**RE: Sheetz (Veterans Drive)
Land Development Submission Review #1
Mount Joy Township, Lancaster County
RGS Project No. 2024A84-019**

**RE: Sheetz – Elizabethtown, PA (Veterans Drive)
Modification Request
Mount Joy Township
RGS Project No: 2024A84-019**

Land Development Plan Submission Review #2

Re: Sheetz – Elizabethtown, PA (Veterans Drive)
Preliminary/Final Land Development Plan
Township Permit No. 24-22-FLDP
LCEC Project No: 25-169

EXISTING CONDITIONS EXHIBIT

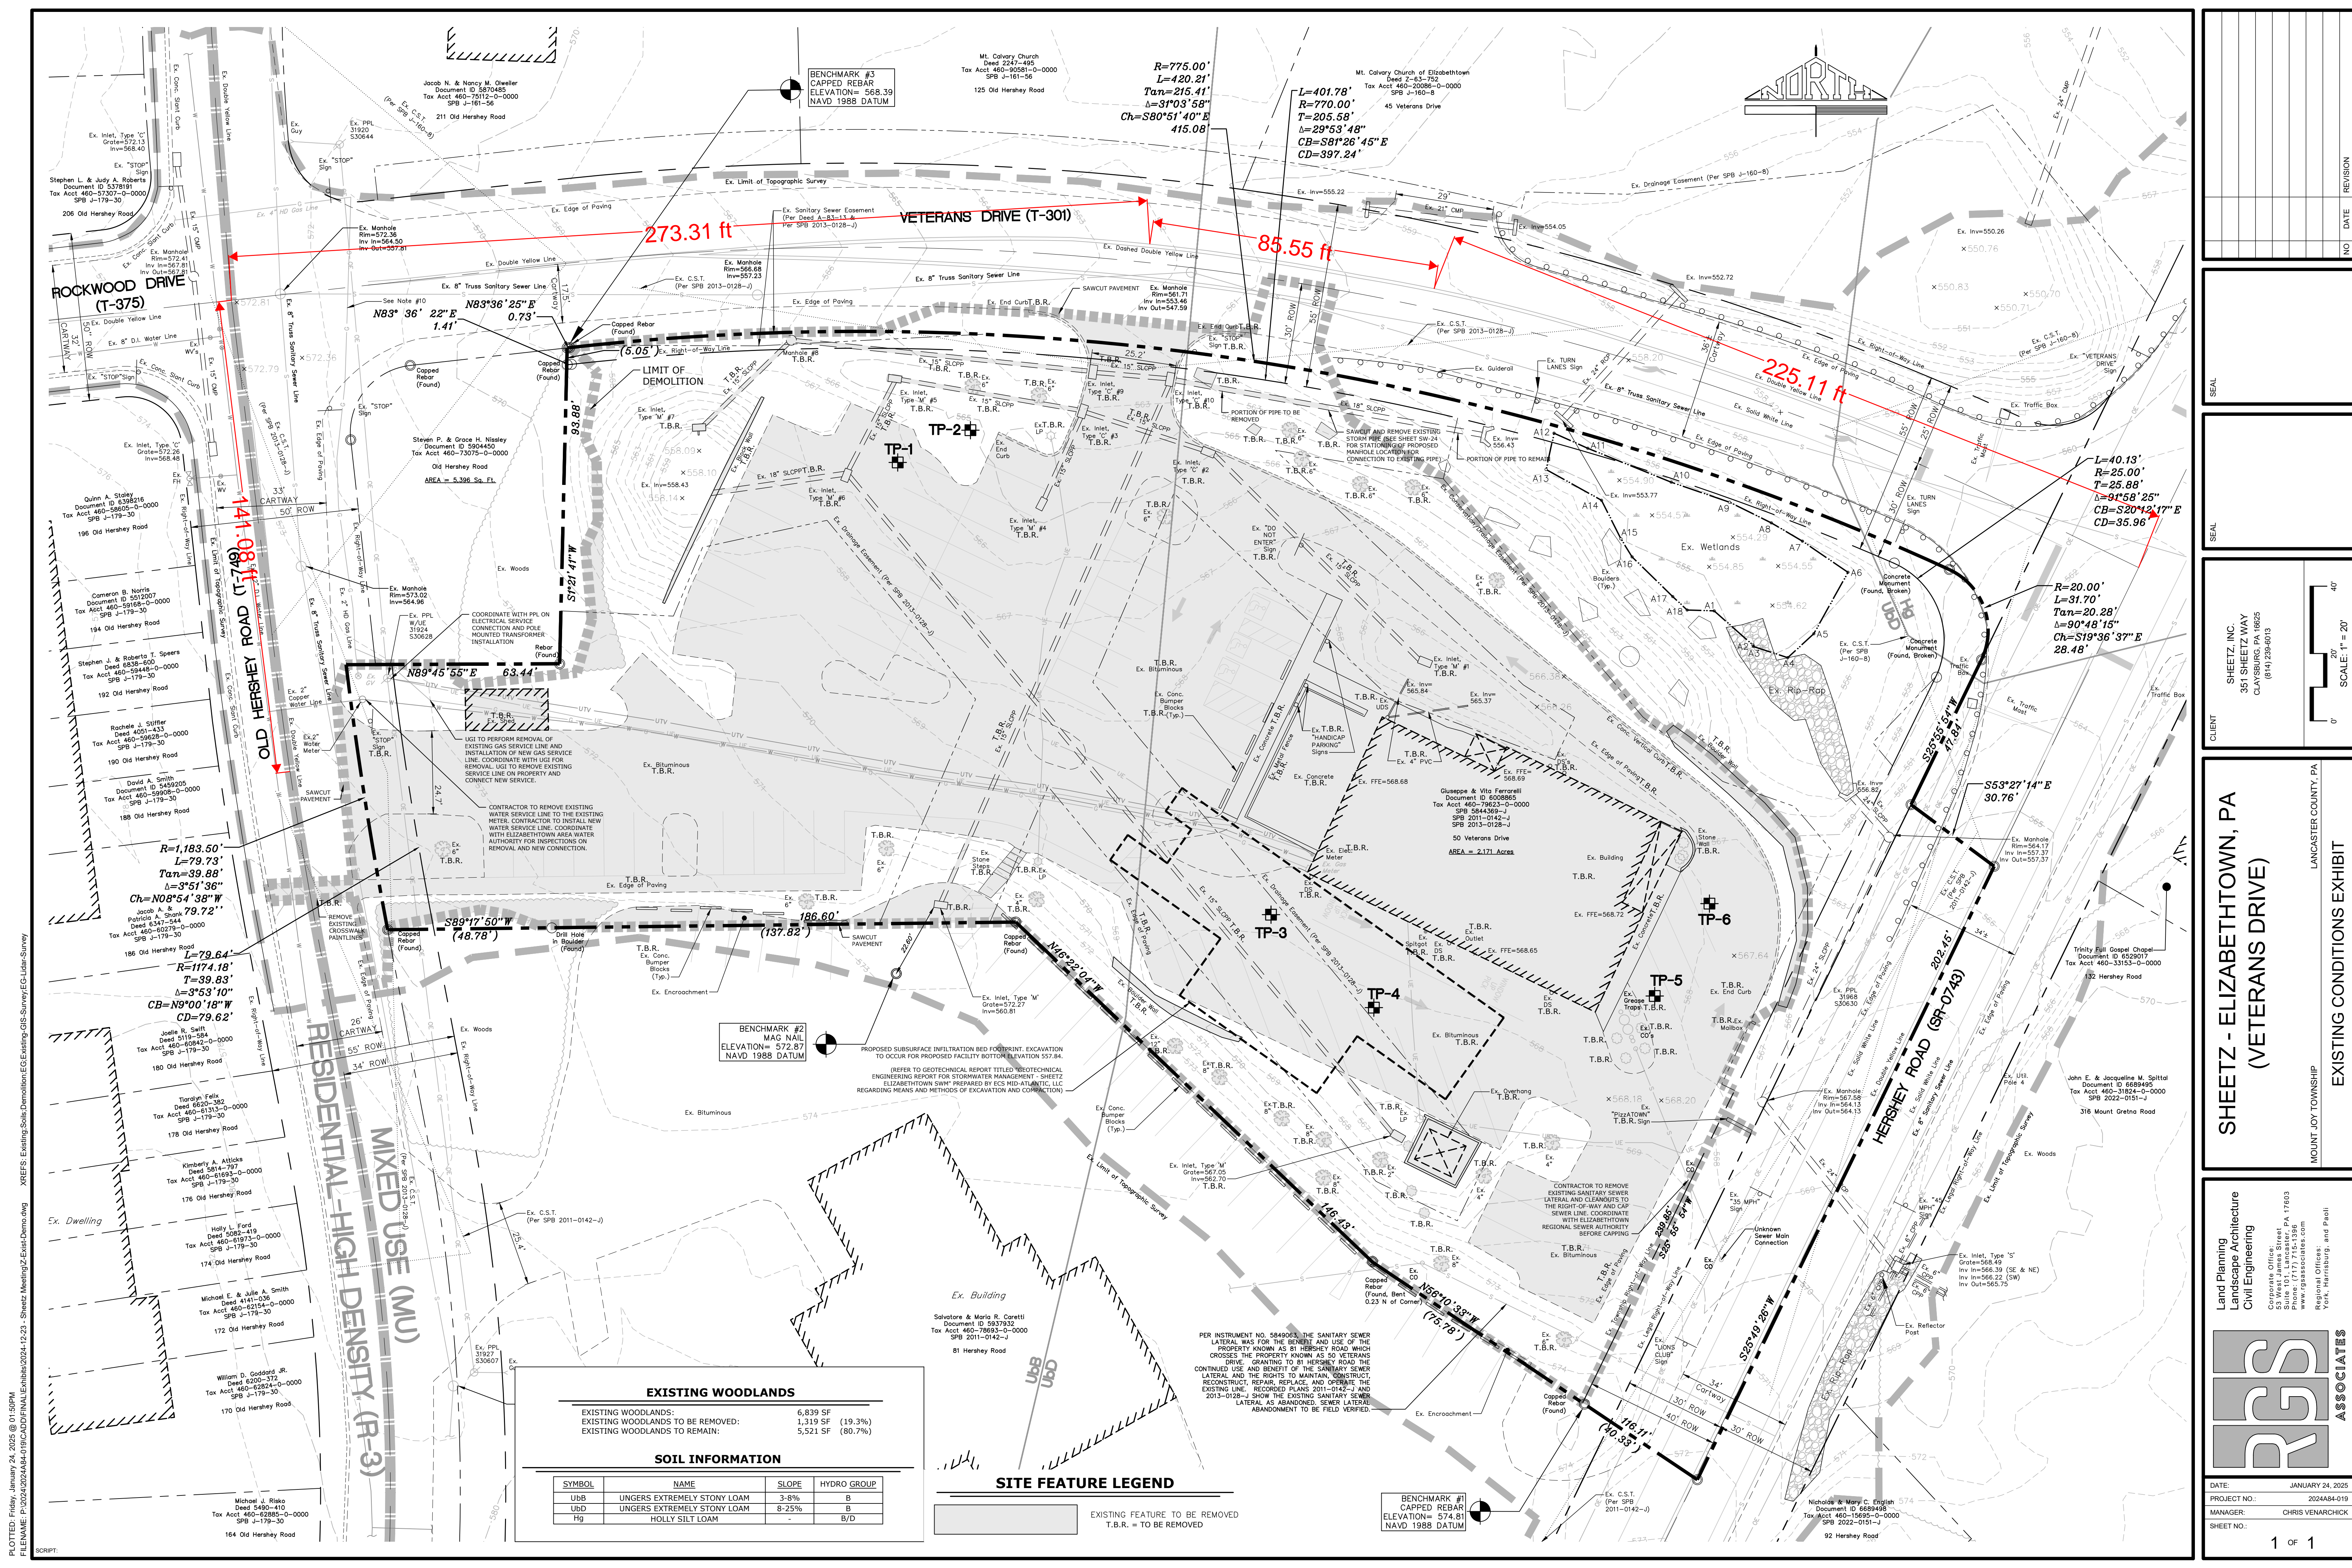
2. All areas within the perimeter of the parking shall be counted (i.e. access drives, aisles, islands, and curbed areas) (135-299.D(2)(a)).
3. Slopes greater than 15% shall be shown on the plans, as well as a differentiation of slopes between 15% and 25% and those greater than 25% (135-305.A). The existing conditions plan shall meet this requirement.
